ENCORE 65
 BD. # 98850171 (10/3/83)
 BD. # 98850172 (6/16/84)

P/N 81501141

ENCORE 65

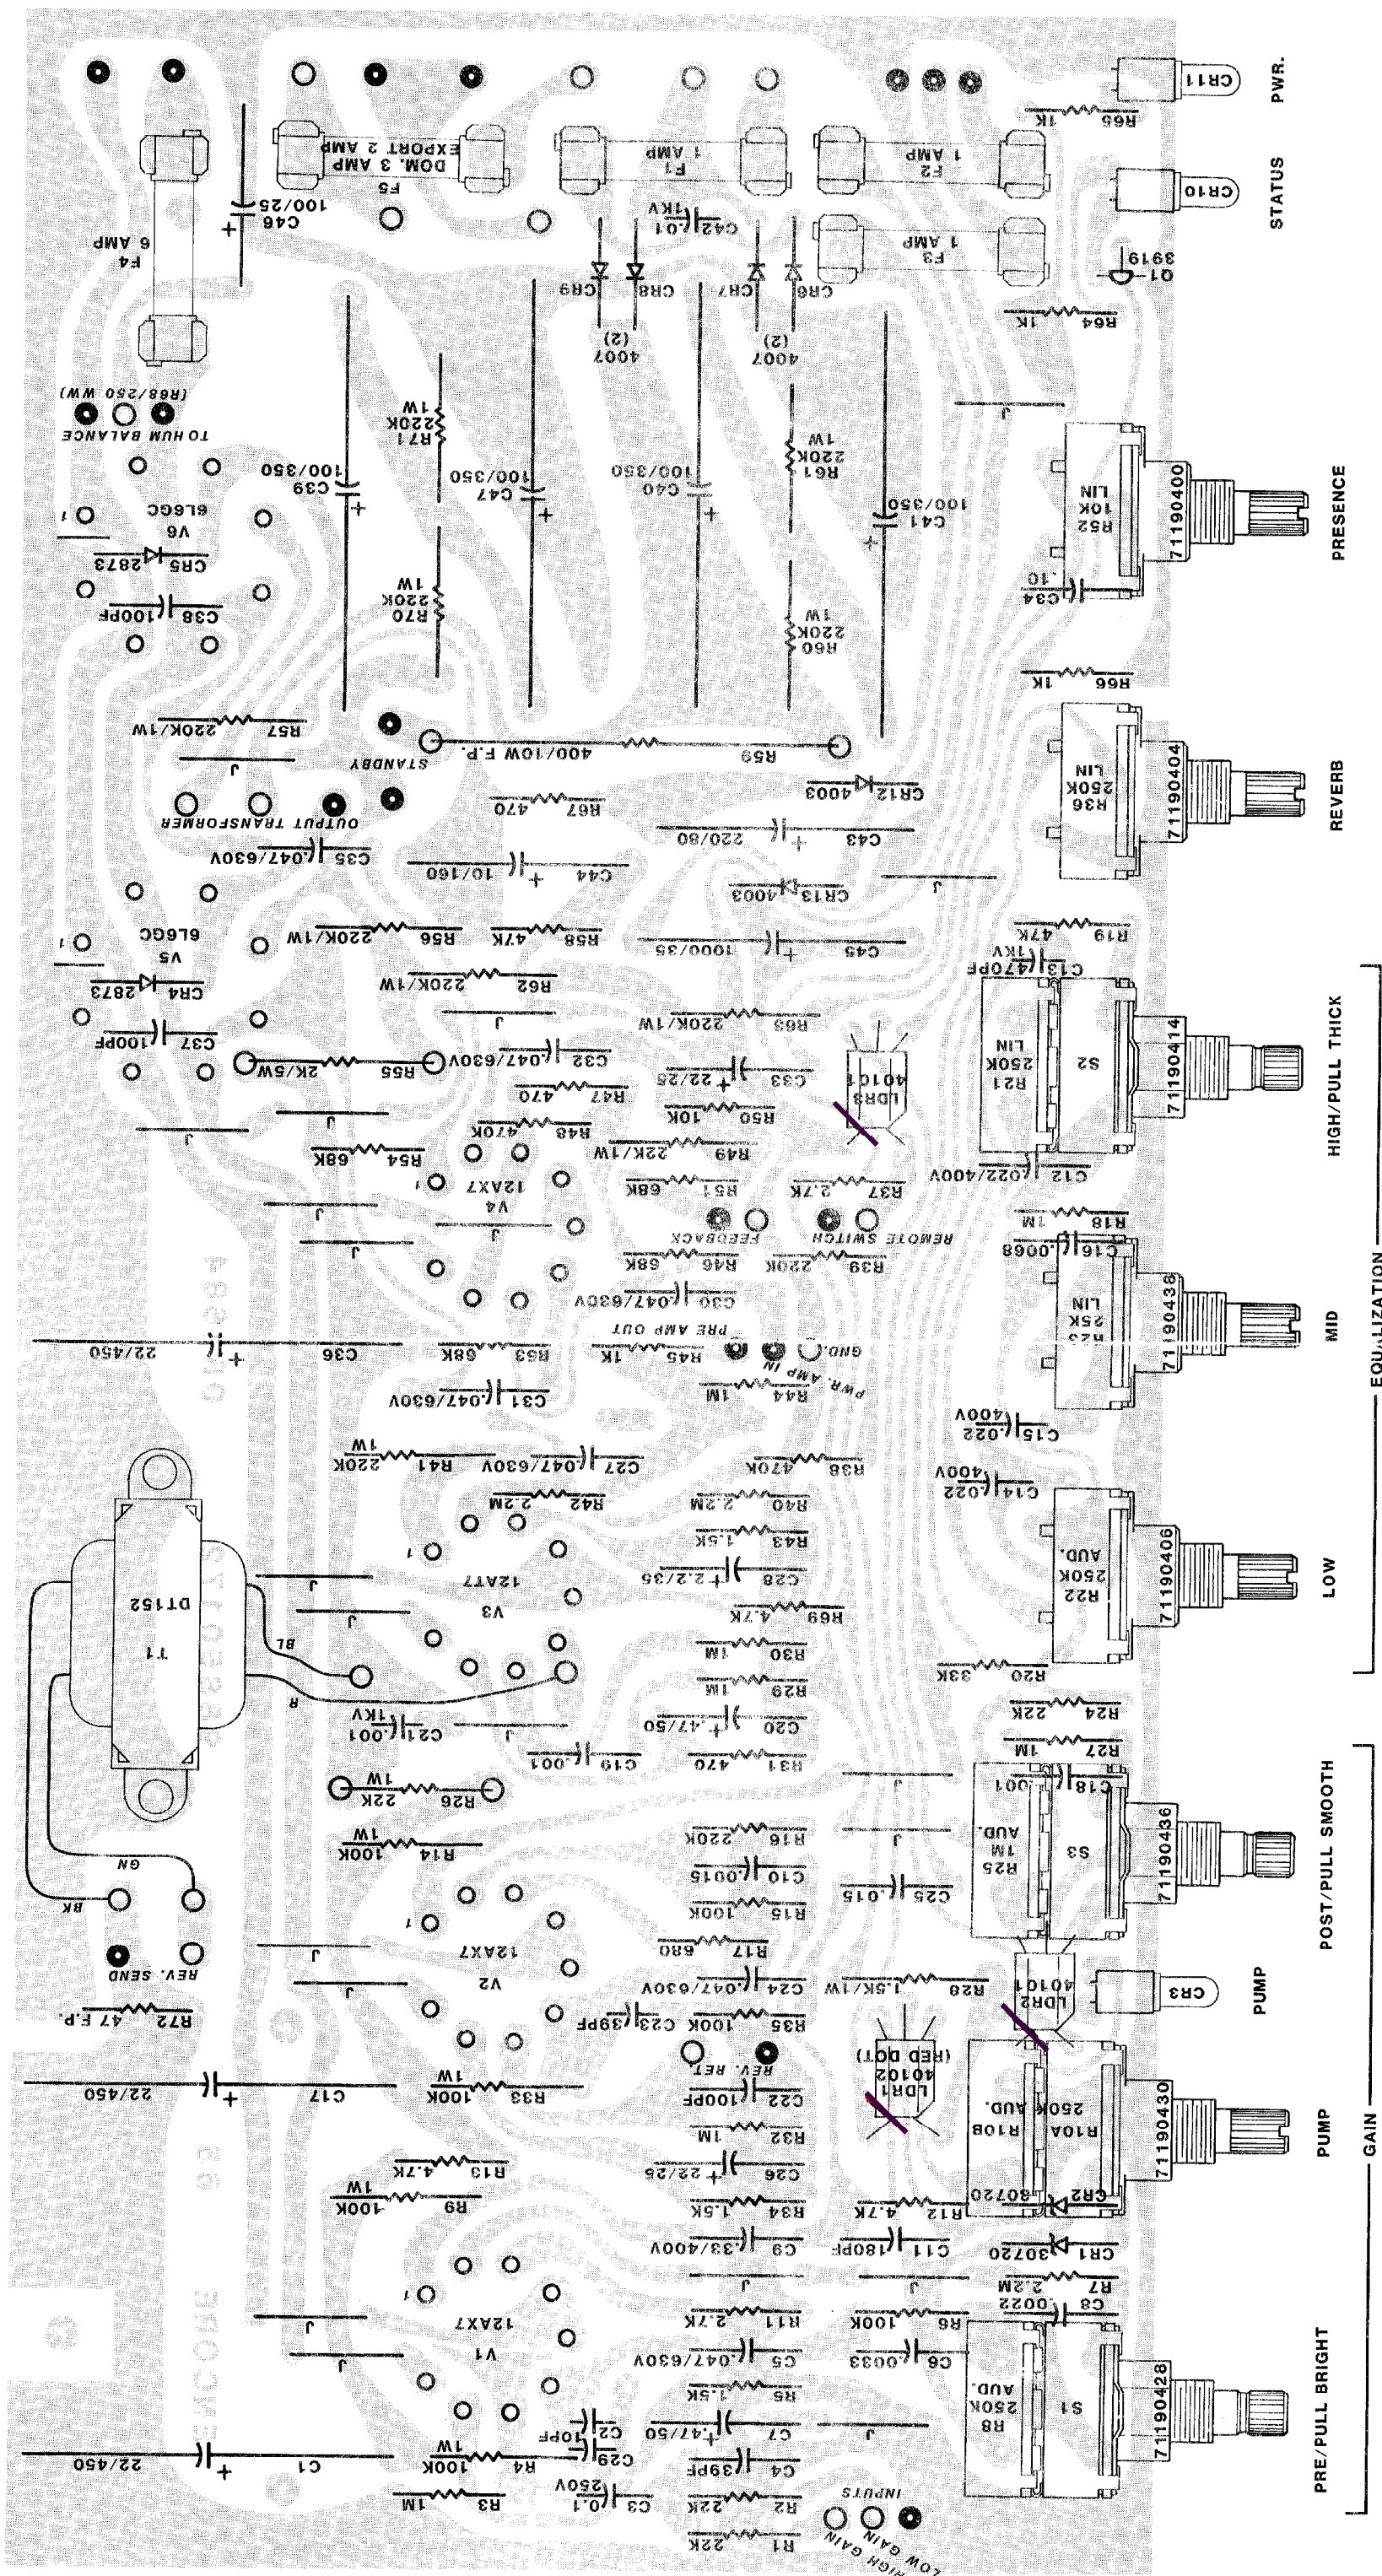
*Please Note: The LDR's are drawn incorrectly on the layout. The flats should be positioned away from the pots as per the added lines. The schematic itself is correct.
